# Access Compliance Report

## Public Rights-of-Way

Intersection ID: 14432	Main Street: AMHERST_PL	Cross Street: QUEENS_RD	Location: SW
ADA ID: E4A5D96F208D	Ramp Type: Directional1	Initial Pass/Fail: Fail	Overall Compliance: No
Severity Score: 37.5			
Codes/Mitigation Info/Possible Solution		Field Measurements/Component Compliance

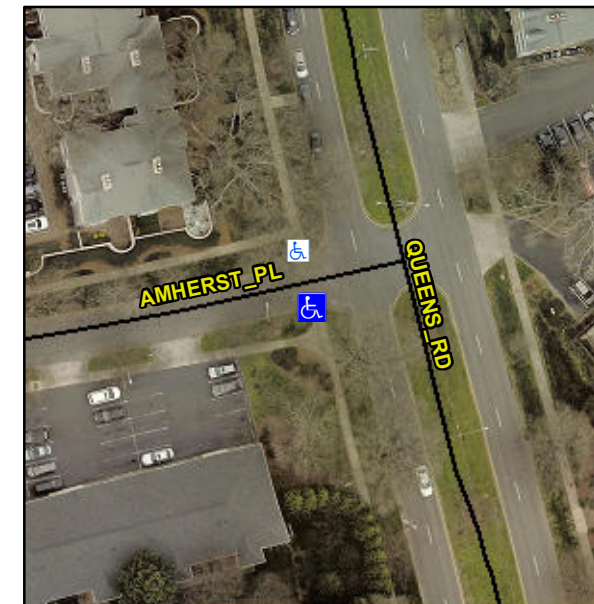
**R304.2.2, R304.5.3**

Compliance	Description	Data	Compliance	Description	Data
N/A	Ramp Length (in)	44.0	N/A	Grade Break?	N/A
Yes	Ramp Width (in)	48.0	N/A	Grade Break Slope (%)	0.0
No	Ramp Slope (%)	9.6	N/A	Grade Break XSlope (%)	0.0
No	Ramp XSlope (%)	12.2			
N/A	Flare Type LT	N/A	N/A	Flare Type RT	N/A
N/A	Flare Slope LT (%)	N/A	N/A	Flare Slope RT (%)	0.0
N/A	Flare Traversable LT?	N/A	N/A	Flare Traversable RT?	N/A
N/A	Landing Length (in)	0.0	N/A	DWS Provided?	N/A
N/A	Landing Width (in)	0.0	N/A	DWS Contrast?	N/A
N/A	Landing Slope (%)	0.0	N/A	DWS Length (in)	N/A
N/A	Landing X Slope (%)	0.0	N/A	DWS Full Width?	N/A
N/A	Landing Curb? (Y/N)	N/A	N/A	DWS Offset LT (in)	N/A
N/A	Shared Landing?	N/A	N/A	DWS Offset RT (in)	N/A
N/A	Gutter Ponding?	0.0	N/A	Gutter Slope (%)	N/A
N/A	Gutter Lip Ht (in)	0.0	N/A	Gutter X Slope (%)	N/A
N/A	Painted X Walk1?	No		Road Slope (%)	8.9
	X Walk 1 Direction	To NW		Road X Slope (%)	0.8
	X Walk 1 Width (in)	N/A		Clear Space?	N/A

X Walk 1 Slope (%)	8.9	N/A	Clear Space to XWalk (in)	N/A
	X Walk 1 X Slope (%)	0.8	N/A	Storm Grate/Utility Hazard?	N/A
N/A	Ramp inside XWalk1?	N/A		Storm Grate/Utility Type	
N/A	Any Obstructions?	N/A			N/A
	Obstruction Type		Yes	Surface Condition? (G/P)	Good
			N/A	Curb Slope (%)	2.1

**Remove & Replace Entire Ramp.**
